**BLOOMINGTON PLAT COMMITTEE
STAFF REPORT**

**CASE #: DP-12-25 / SUB2025-04-0044
DATE: April 7, 2025**

REQUEST: The petitioner is requesting secondary plat approval for amendment of Section V Phase I of the Ridgefield Subdivision.

**CASE #: DP-13-25 / SUB2025-04-0045
DATE: April 7, 2025**

OWNER:
ROBERT V. SHAW
2005 S. ROGERS ST. #59
BLOOMINGTON, IN 47403
PROJECT NO. 6015
PLAT DATE: JUNE 15, 2009
SHEET 1 OF 1

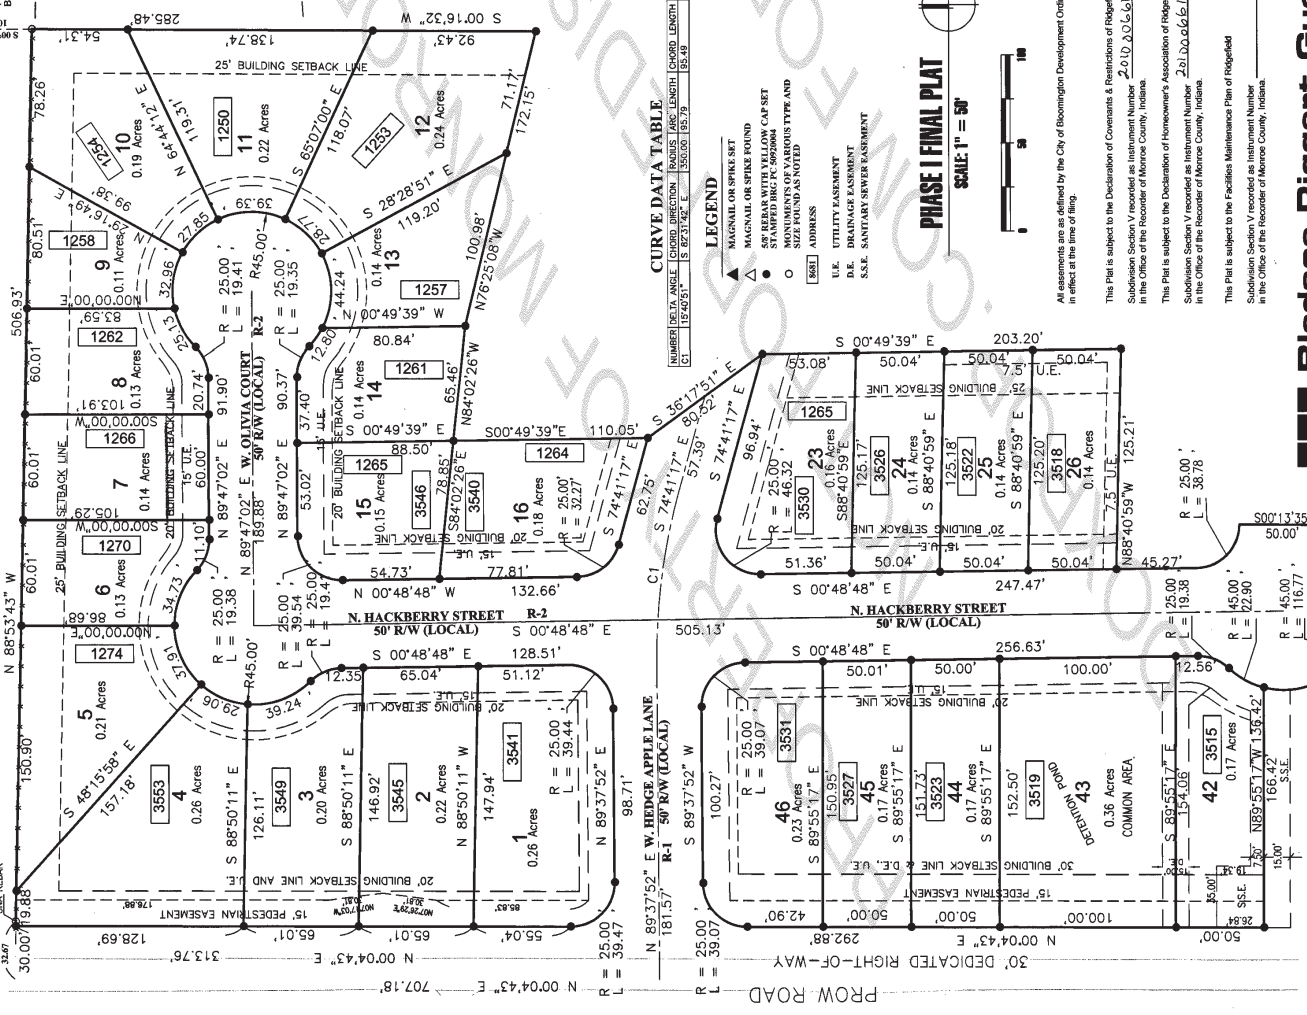
The petitioner is requesting secondary plat amendment approval for Section V Phase I. The request is to alter Lot 42, making it a common area lot, and combining lots 23-26 into 3 lots.

Parcel Development Standards: The Ridgefield PUD permits 5,000 square foot lot minimums, with 20 foot front yard setback minimums. Side yard setbacks are a minimum of 6 feet, with a combined setback of 15 feet, regardless of stories. Lot width is referred to as ‘typically 50 feet’ and some lots under 50 feet have been allowed in the PUD. Lot width for Lot 42 is being reduced to 50 feet. All other amended lots are increasing in width. The dimensional standards shown for the developable lots in the amended secondary plat are compliant with the Outline/Preliminary Plan of the PUD and the primary plat. Lots 42 and 43 will be common area lots, with Lot 43 containing a detention pond.

Lot Access: Amended lots 21 through 23 will have vehicular access to N. Hackberry Street.

Stormwater Standards: Lots 42 and 43 include a drainage easement that extends through Lot 41 to the south in Phase II. Although the proposed subdivision has not yet achieved CBU approval for the drainage plan, the petitioner has worked with CBU staff toward compliance and will continue to do so.

Road Design: The only right-of-way change is related to the eyebrow design. The petitioner proposes to leave both the eyebrow shown at the southwest portion of the development and the new cul-de-sac, Bradley Court, at the southeast portion of the development. The petitioner received subdivision waiver approval to allow the eyebrow and cul-de-sac as part of the design. The secondary plat road design is compliant with the primary plat, and only includes slight changes to the recorded design of the eyebrow.

RECOMMENDATION: The Planning and Transportation Department recommends that the Plat Committee approve the secondary plat of DP-12-25 / SUB2025-04-0044 based on the findings of fact above and with the following conditions:

1. This approval is subject to Plan Commission case #PUD/DP-24-21 and its conditions.
2. The petitioner shall remove easement language for easements that do not appear on the plat before the plat will be signed and released for recording.
3. Right-of-way dedication language shall be added before the plat will be signed and released for recording.
4. The signature block will be updated before the plat will be signed and released for recording.

RIDGEFIELD SUBDIVISION PHASE V, SECTION 2
SECONDARY PLAT
A PART OF THE EAST HALF OF THE NORTHEAST QUARTER OF
SECTION 20, TOWNSHIP 9 NORTH, RANGE 1 WEST,
BLOOMINGTON TOWNSHIP, MONROE COUNTY, INDIANA

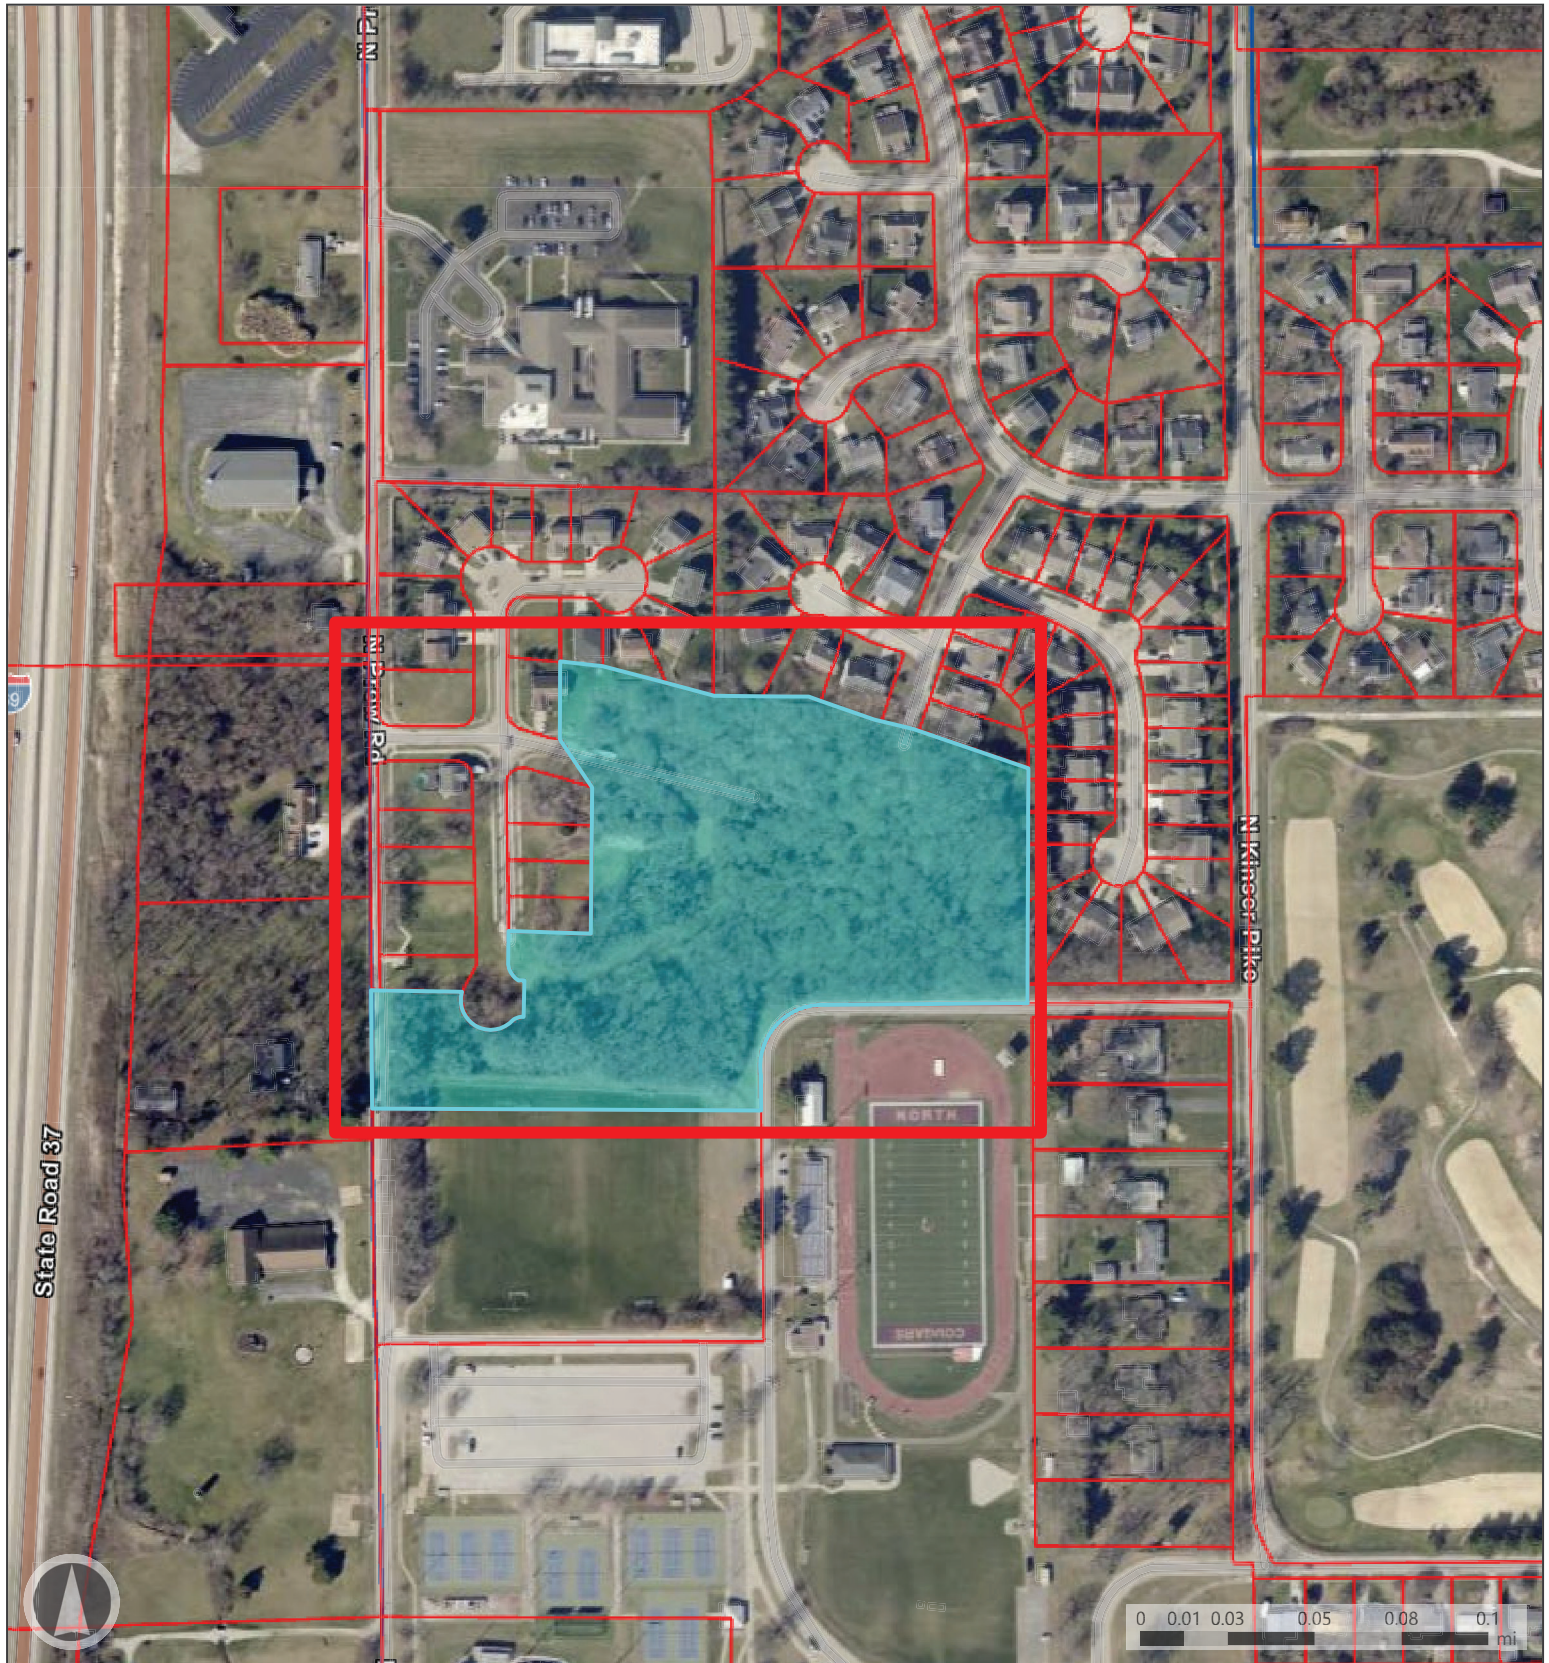
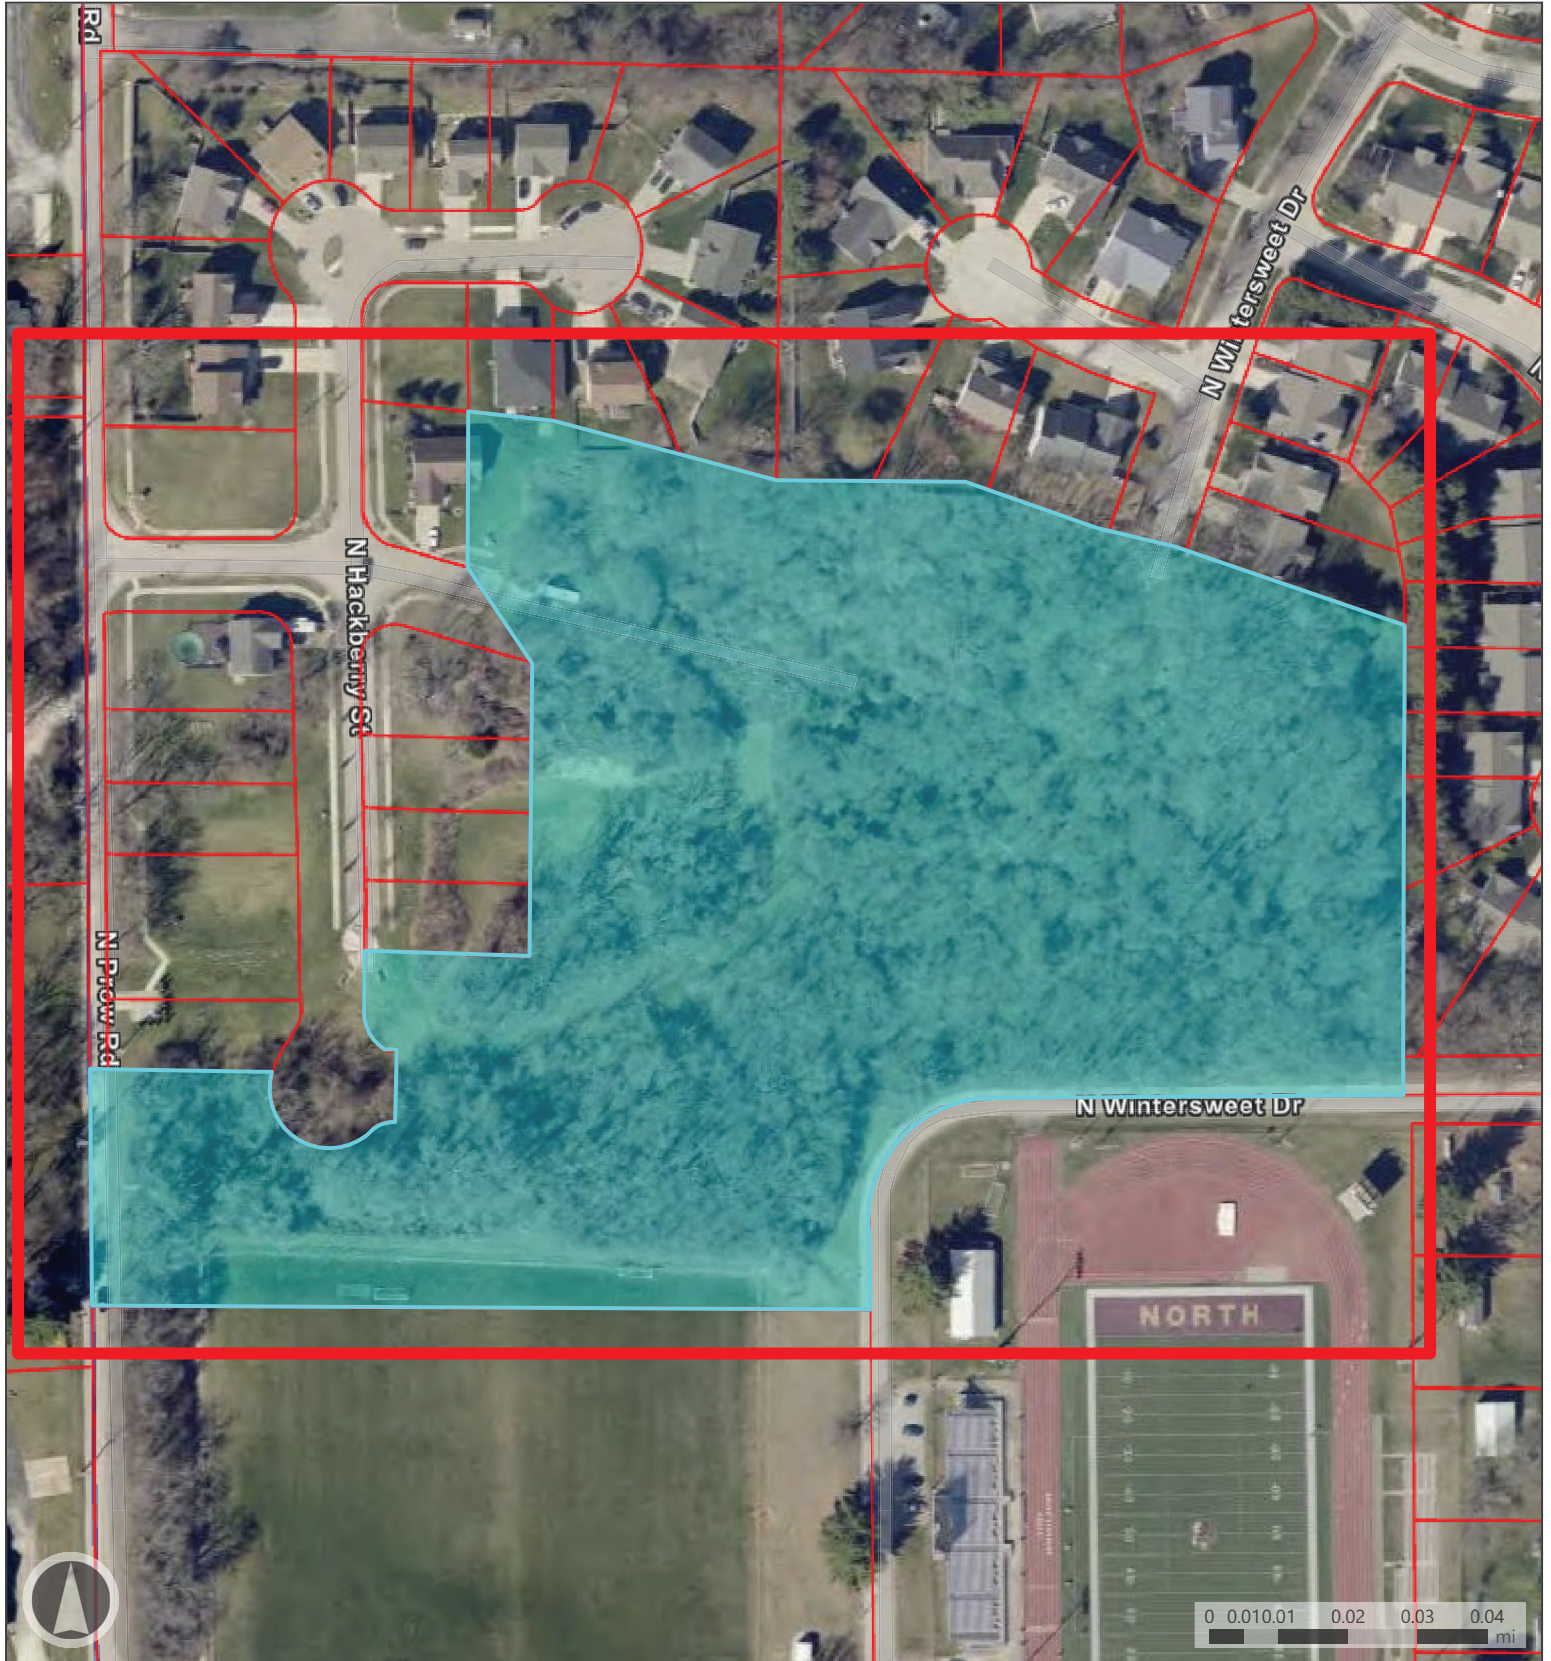
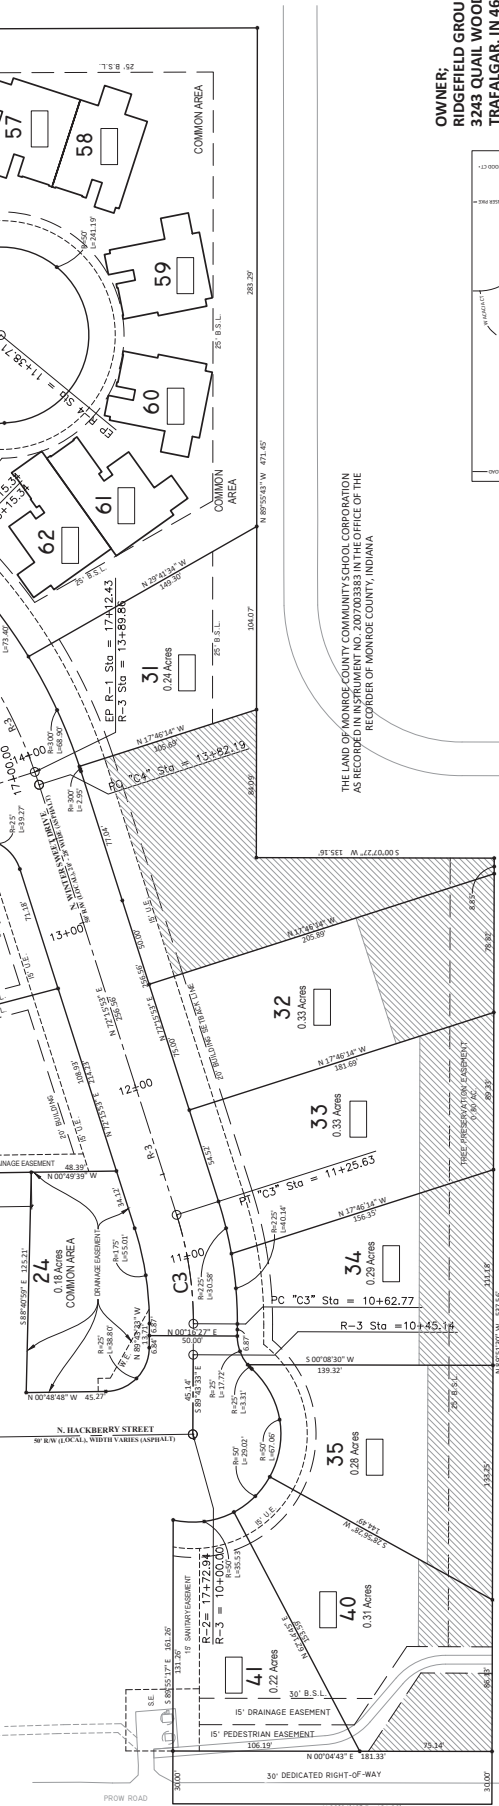
Parcel Development Standards: The Ridgefield PUD permits 5,000 square foot lot minimums, with 20 foot front yard setback minimums. Side yard setbacks are a minimum of 6 feet, with a combined setback of 15 feet, regardless of stories. Lot width is referred to as ‘typically 50 feet’ and some lots under 50 feet have been allowed in the PUD. The dimensional standards shown for the developable lots in the secondary plat are compliant with the Outline/Preliminary Plan of the PUD and the primary plat. Common area lots surrounding Lots 47-62 has been labeled, as required by a condition of approval of PUD/DP-24-21.

Stormwater Standards: Lot 41 includes a drainage easement on the western portion of the lot. The drainage easement extends north into Lot 42 of Phase I, and into a detention pond on Lot 43. Although the proposed subdivision has not yet achieved CBU approval for the drainage plan, the petitioner has worked with CBU staff toward compliance and will continue to do so.

Road Design: The petitioner has elected to largely utilize the 2008 designed primary plat for this petition related to road design, and there are a number of items that differ from the required current UDO standards. The first is the width of the right-of-way. The other portions of this PUD utilize a 50 foot right-of-way, as was standard in 2008 for this type of road, but the current UDO requires 60 feet of right-of-way, via the Transportation Plan requirements. The petitioner has worked with the City Engineer on the design of the

roadway, and although the width of the right-of-way will not meet UDO standards, the width of the pavement will, at 28 feet. The Transportation Plan allows for the Department Director to approve the 50 foot width.

The UDO does not allow for culs-de-sac or eyebrow design. The petitioner proposes to leave both the eyebrow shown at the southwest portion of the development and the new cul-de-sac, Bradley Court, at the southeast portion of the development. The petitioner received subdivision waiver approval to allow the eyebrow and cul-de-sac as part of the design. The secondary plat road design is compliant with the primary plat.

Environmental Considerations: The tree preservation easement on the southern end of the development has been labeled as such on the plat, as required by a condition of approval of PUD/DP-24-21.

RECOMMENDATION: The Planning and Transportation Department recommends that the Plat Committee approve the secondary plat of DP-13-25 / SUB2025-04-0045 based on the findings of fact above and with the following conditions:

1. This approval is subject to Plan Commission case #PUD/DP-24-21 and its conditions.
2. The petitioner will submit a street lighting plan before the plat will be signed and released for recording.
3. The petitioner shall remove easement language for easements that do not appear on the plat before the plat will be signed and released for recording.
4. Right-of-way dedication language shall be added to page 2 before the plat will be signed and released for recording.
5. The signature block will be updated before the plat will be signed and released for recording.
